Powertex Fashions Ltd (Extension)

21 August 2023

Observations

Bore hole layout and approximate Building-2 location (marked)

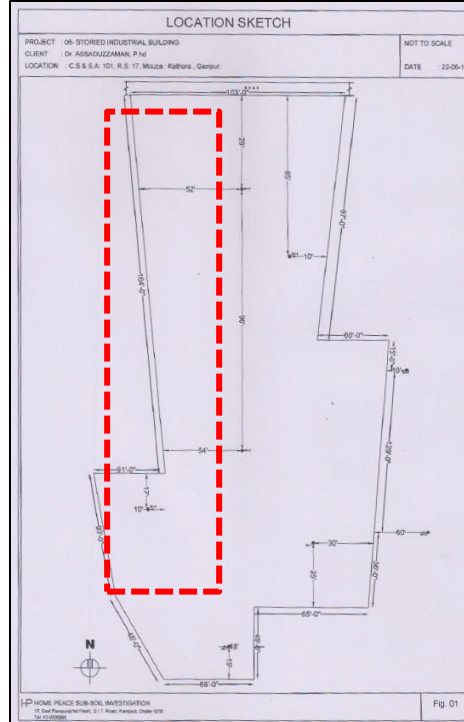
In EA report, the of footing capacity has been shown more than FoS-2.5 considering allowable bearing capacity 1.52 tsf (FoS-3) for BH-01. But the BH-01 is far away from the building-2 where the BH-03 & BH-07 are nearer to Building-2. Considering the allowable bearing capacity 0.849 tsf (FoS-3) for BH-03 & BH-07, the footing capacity was found marginally overstressed for few footings. Factory engineer is required to revise the EA considering actual bearing capacity of soil and suggest the factory for remedial works if required.

Floor loading mismatch with load plan

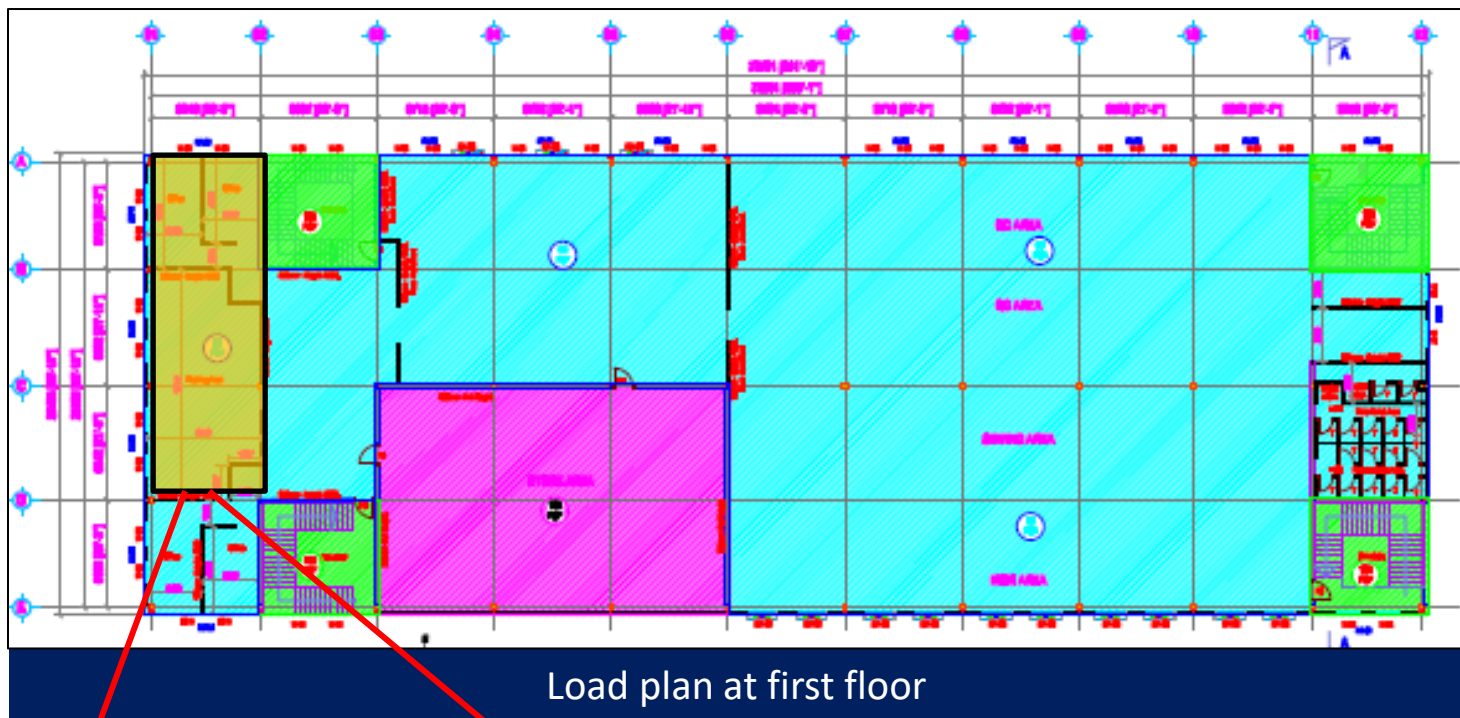
In the load plan 3kPa floor loading has been considered. During inspection, storage was found in the marked location. Building Engineer is required to implement the floor load management system.

Discrepancy between as-built drawing & site condition

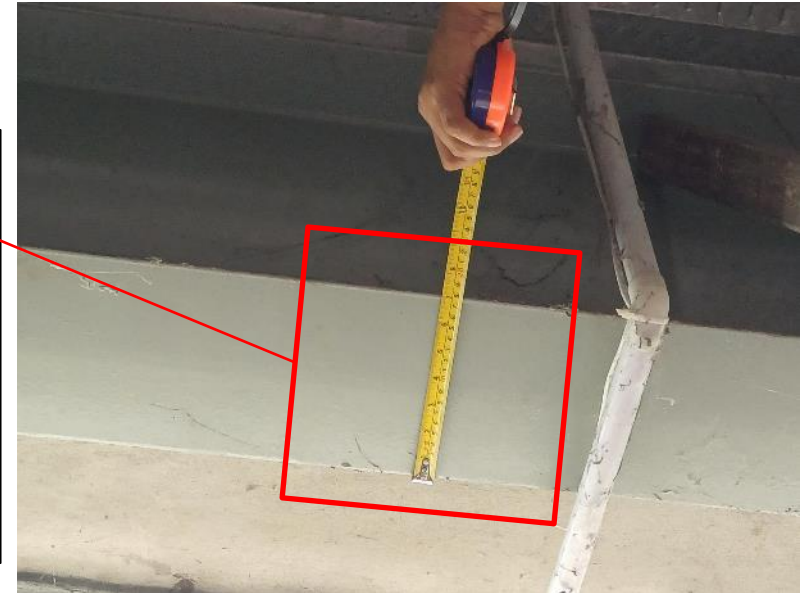
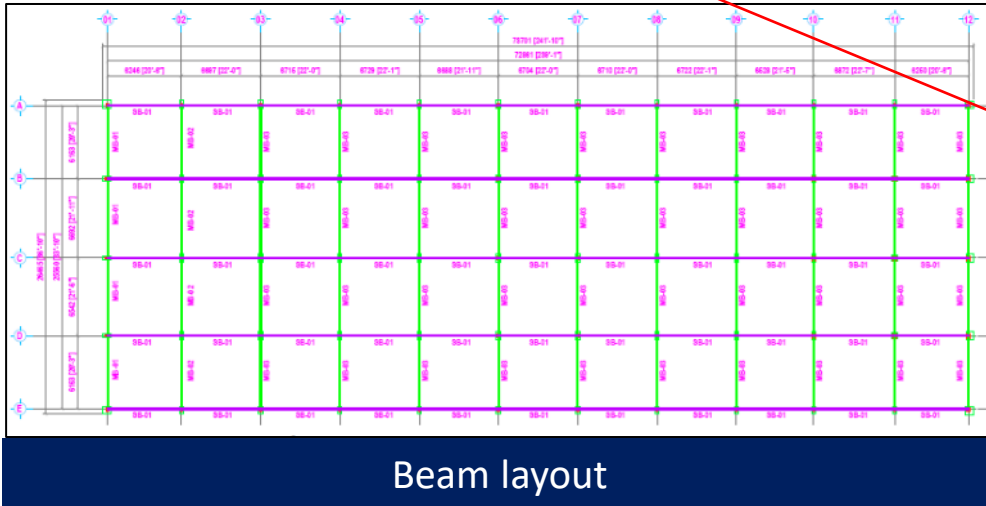
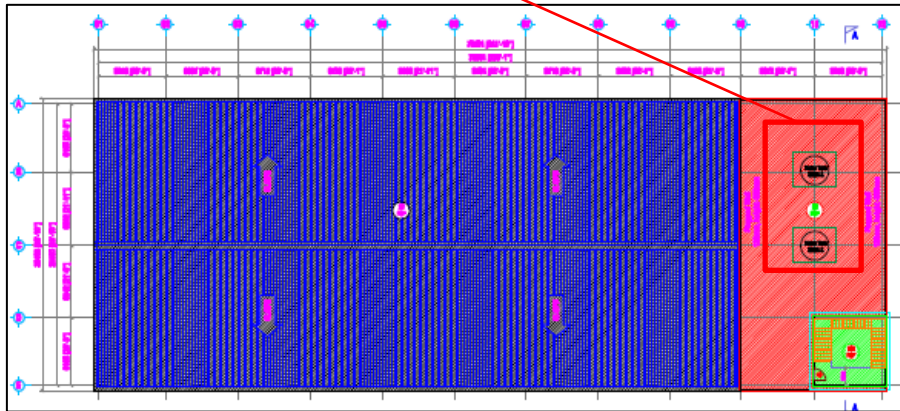
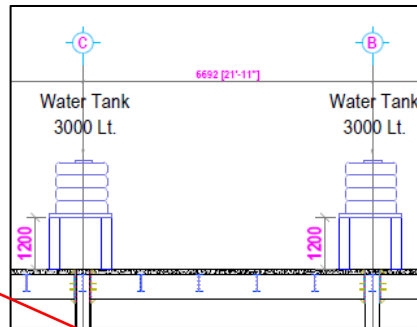
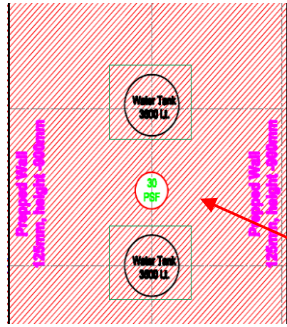
Flange width of MB-01 beam was found 175 mm instead of 200 mm

Mismatch found in steel beam size. Building Engineer is required to survey the structure and update the as-built drawings. Revise the assessment as per the updated as-built drawing.

Bracing Connection and Column & Beam connection

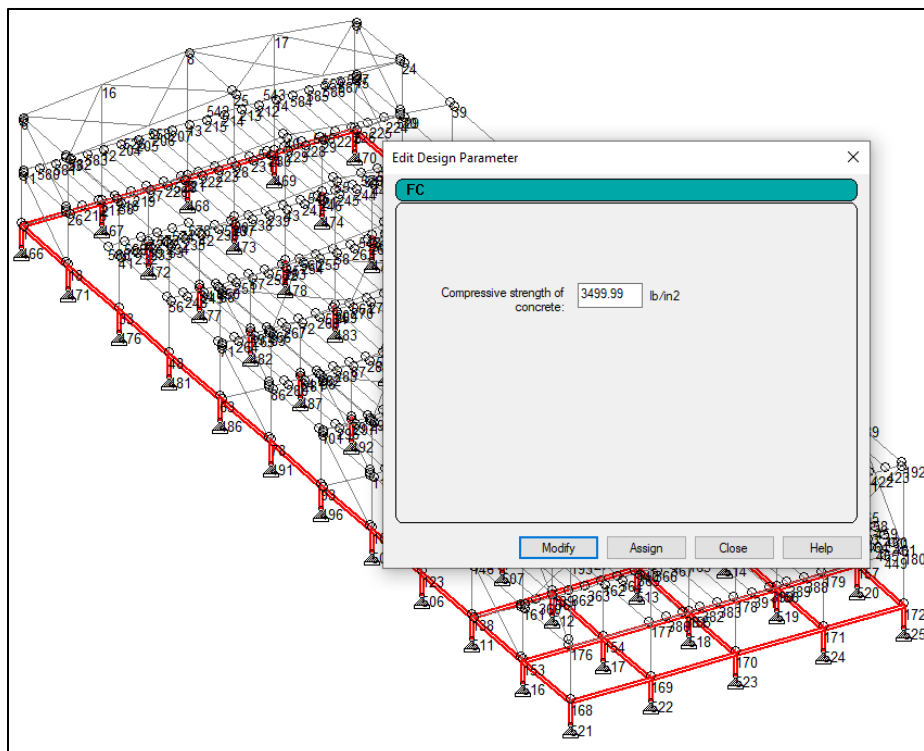
Connection details was found missing in the drawings. Building Engineer is required to include connection details in as built drawings and provide all types of connection adequacy check in EA report.

Exposed re-bar at roof.

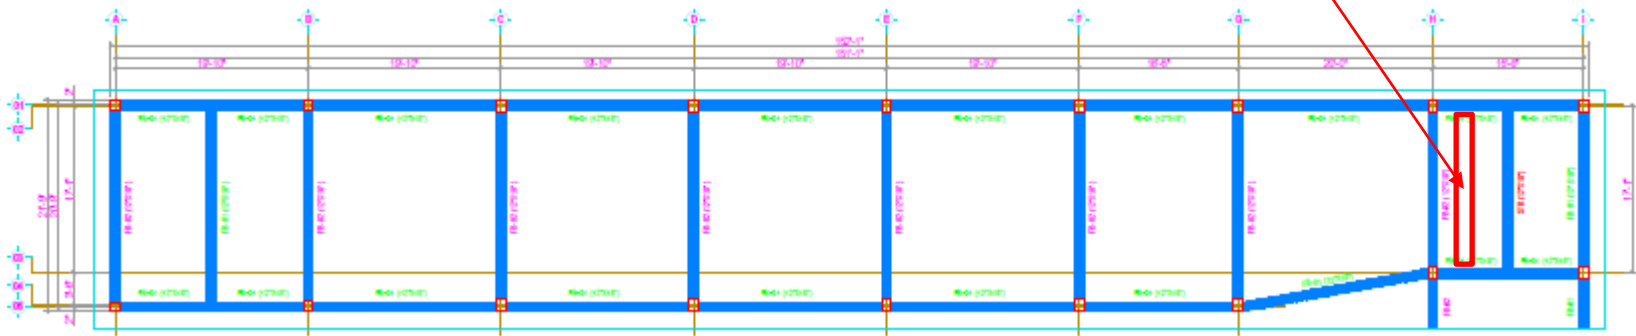
Exposed corroded rebar at roof

Building engineer is required to identify the exposed corroded rebar and take adequate measures to protect exposed rebar from corrosion.

Column size mismatch with as built drawings in below ground level

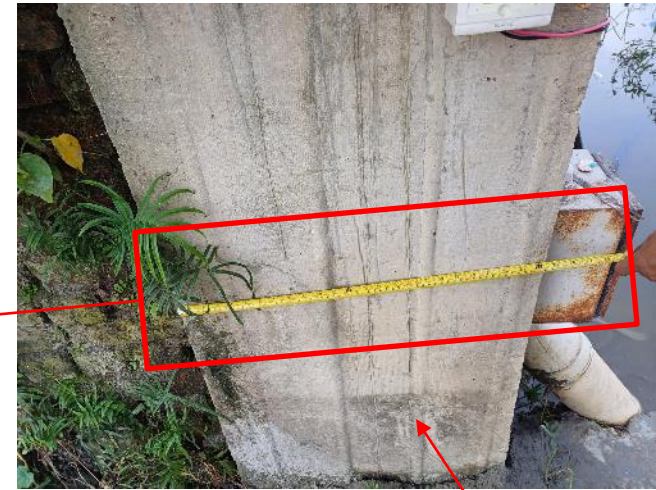
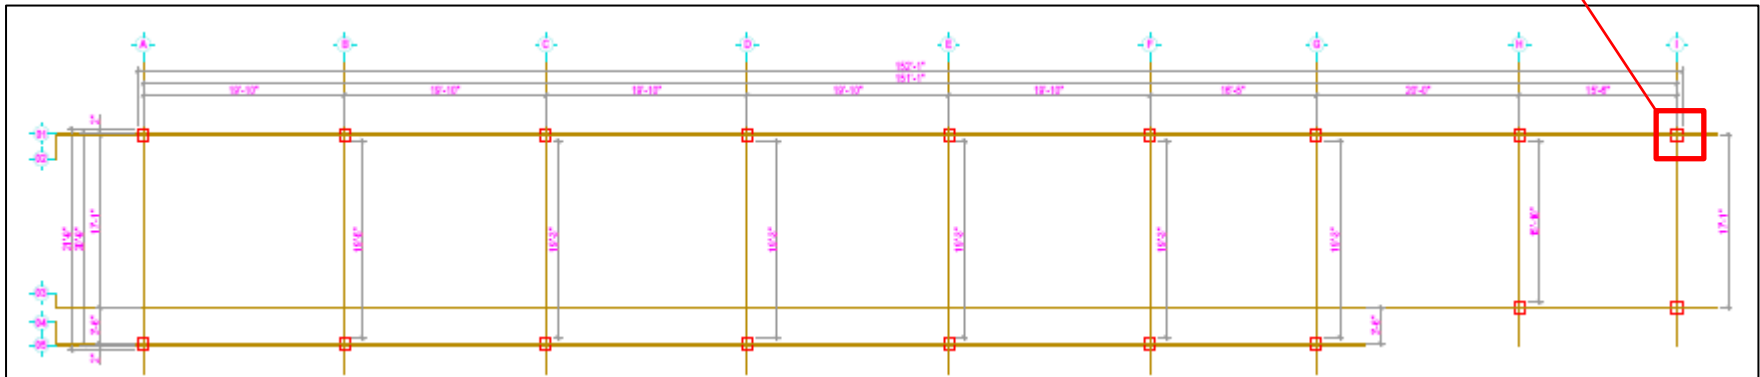
During inspection column size found 24"x12" instead of 16"x24". Building engineer is required to check the column size and update drawings as per site condition.

Engineering assessment (EA) needs to revise

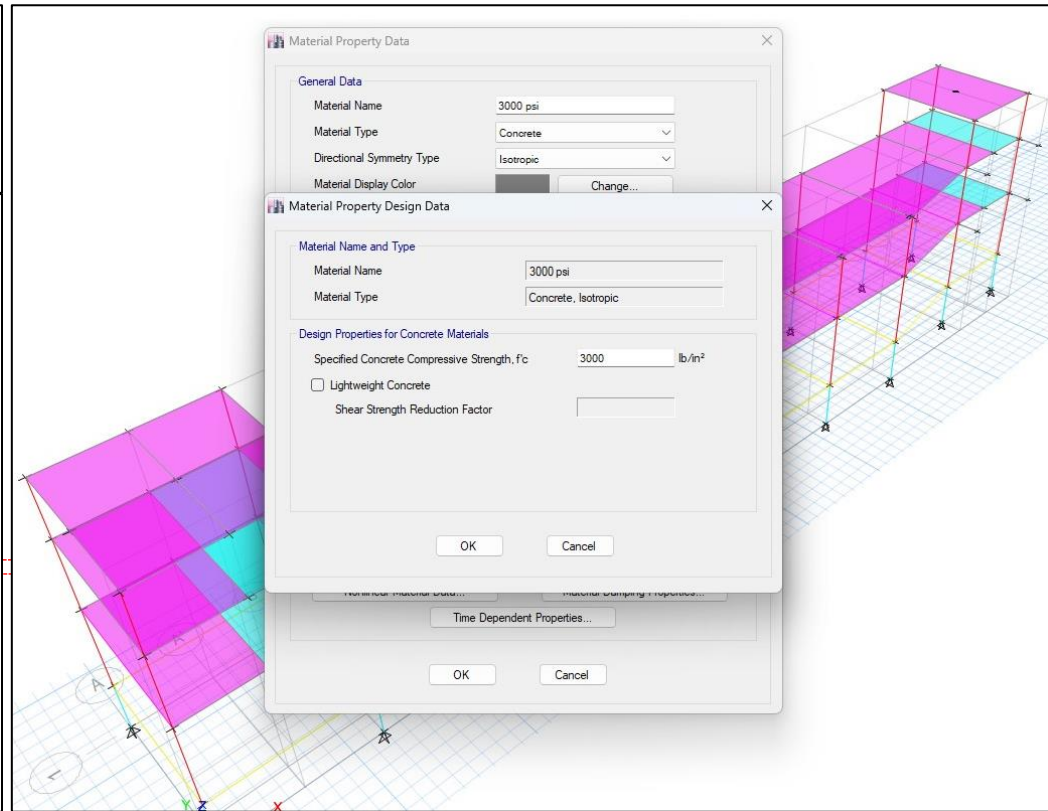
Concrete strength has been considered 3 ksi in FEA model and general note of the construction drawing and in engineering assessment report. Also, the $f_y = 72.5$ ksi has been considered.

The concrete strength has been considered 3 ksi and $f_y = 72.5$ ksi but no credible test report was available to support the strength value. Factory engineer is required avail the proper documents to support the considered concrete strength or provide concrete core test report to check the in-situ concrete strength. For the steel, factory is required to provide the tensile strength test report. Factory engineer is required to suggest the factory authority for the remedial works if required.
